Reviewer 1

Thank you for inviting me to review the paper: “Historical and Projected Future Runoff over the Mekong River Basin” by Wang et al.

Figure 2: The results of the MK trend test in historical (1971-2020) runoff over the

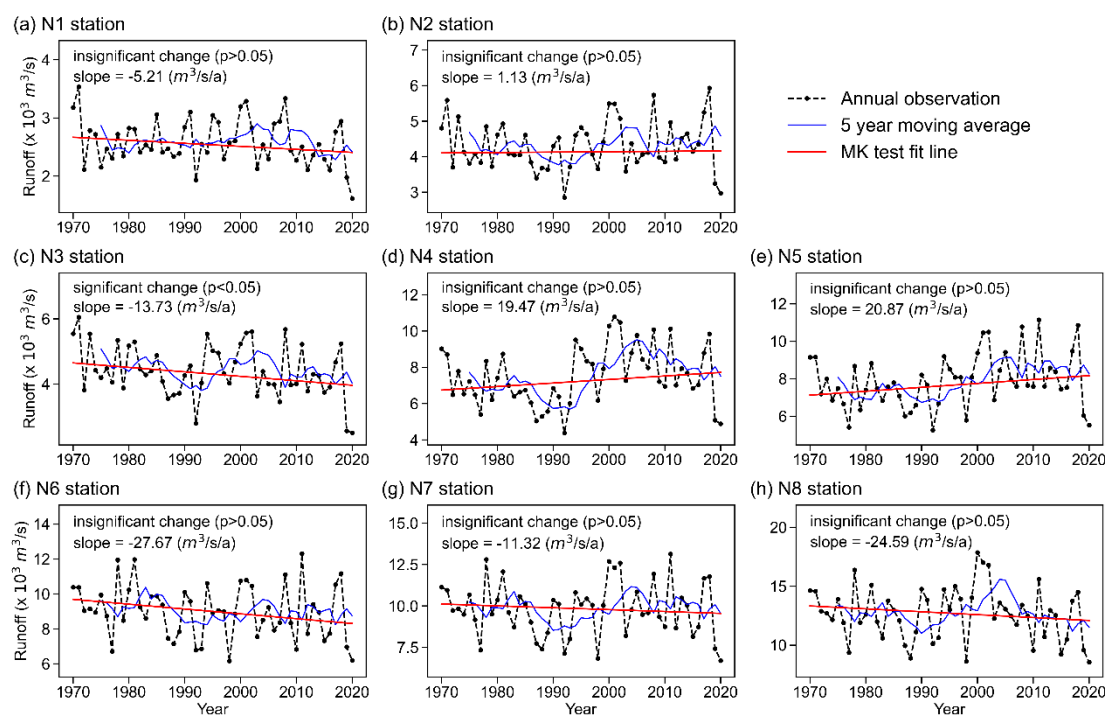
P7, Figure 2 – One possibility to avoid the repeated words “insignificant change” is to give the p-value for the regression. Then where it is significant (e.g. $p < 0.05$), mark with a star symbol. Something like that... Also, again, expand the caption slightly. For instance, state, “Eight hydrological stations are numbered N1-N8, with their locations presented in the map of Figure 1”.

P7, Figure 2. Although very obvious, please put the word “Year” under panels (f), (g) and (h).

Response: Thanks for your helpful suggestions. We have checked the Figure 2 and added p-value where significance tests are involved. We have also changed the caption of Figure 2 in the revised manuscript:

Response: Thanks for your helpful suggestions. We have revised Figure 2 accordingly in the revised manuscript, which can be found in the response to the previous comment.

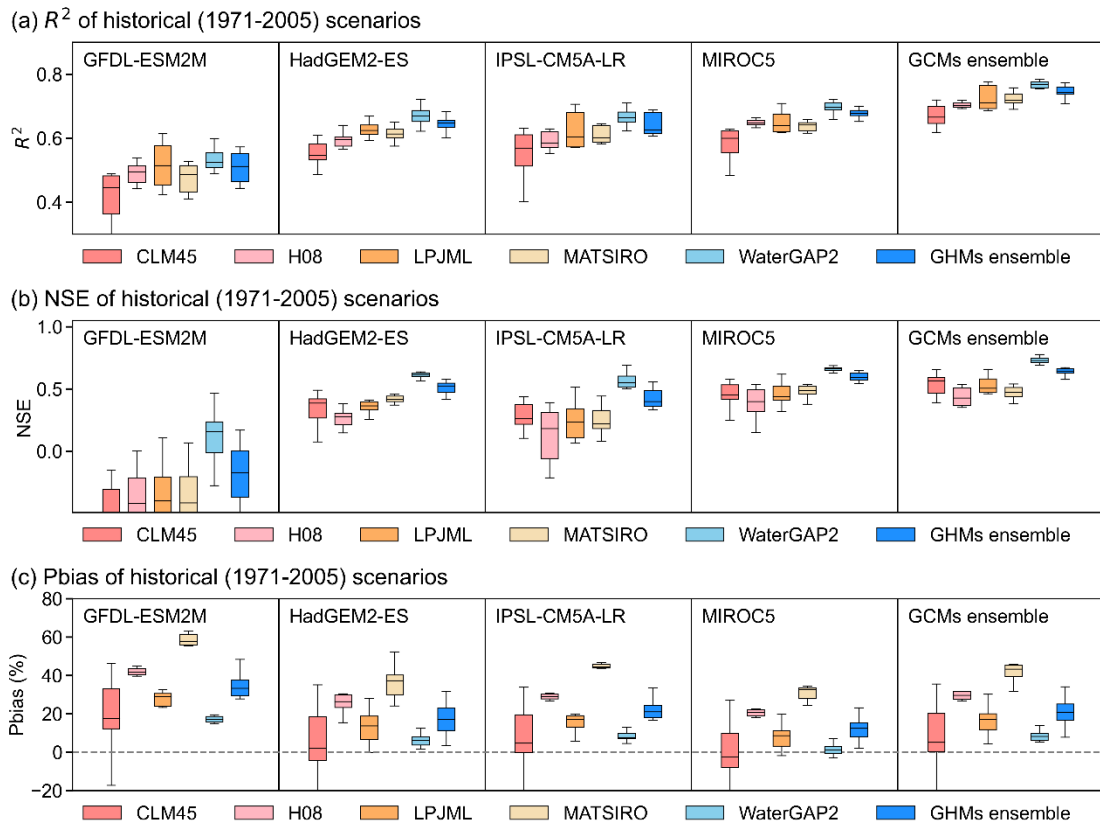
Figure 3. Again, please make the caption much more informative. Something like “Figure 3. Performance of all combinations of GCMs and GHMs. The three rows correspond to three performance matrices..... In each row, each panel is for a different GCM, as annotated. Then in each panel, the different colors are for each GHM, as marked under each row.....”

Figure 3. Although it is important to make captions informative, placing a result there is not usual practice. So please reconsider the words “WaterGap2 has the best performance compared to other models”, and should they be in a caption?

Figure 3. And on the same point above, statements such as “...best performance compared to other models” requires very careful quantification. Is it the best performance when WaterGap2 is driven by a specific GCM? Is it the best for one statistical metric or many?

Response: Thanks for your helpful suggestions. We have changed the caption of Figure 3 in the revised manuscript according to the above suggestions:

“Figure 3. Performance of all combinations of GCMs and GHMs during historical (1971-2005) periods. The three rows correspond to three performance matrices (R^2 , NSE and Pbias) of all GCM-GHM combinations at the eight hydrological stations. In each row, each panel is for a different GCM, as annotated. Then in each panel, the different colors are for each GHM, as marked under each row.”

Response: Thanks for your helpful suggestions. We have removed this sentence from the captions of Figure 3. The revised the captions of Figure 3 can be found in the response to the previous comment.

Response: Thanks for your helpful suggestions. Specifically, we have quantitatively compared three performance metrics of WaterGap2 and other hydrological models under forcing from each of the four GCMs. It was found that WaterGap2 has the highest R^2 and NSE and the lowest Pbias than other GHMs under any *same* GCM forcing. This shows that despite the uncertainty between different GCMs, the simulation of the MRB runoff by WaterGap2 has better performance and reliability than other models. We have clarified this point in Line 141 of the revised manuscript:

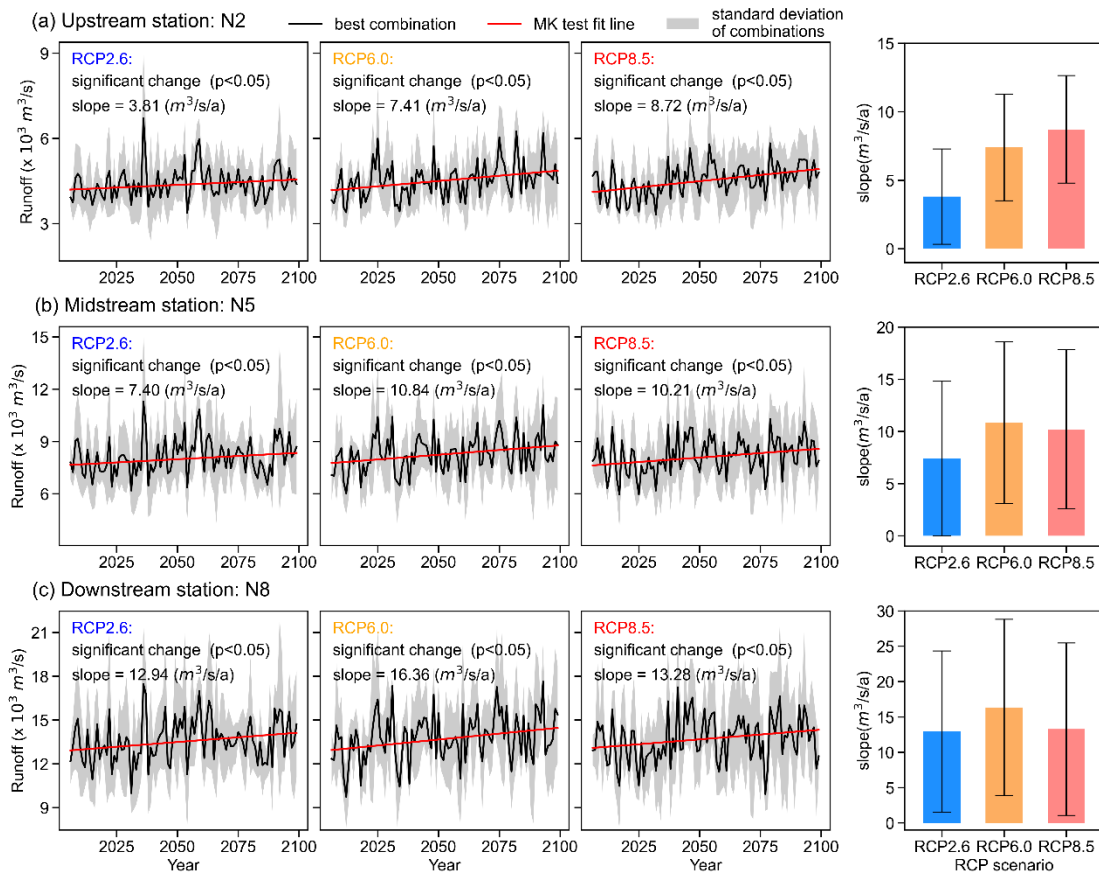
Yes, based on the GHM simulation, the authors were able to reach at the conclusion that runoff in the MRB is projected to increase under climate change scenarios. However, the paper has not presented estimate of uncertainty associated with the projections.

Furthermore, the uncertainty range has been added to Figures 6-7 and Table 4 in the revised manuscript. Meanwhile, the uncertainty range has also been marked in the text in the revised manuscript when quantifying future runoff projections.
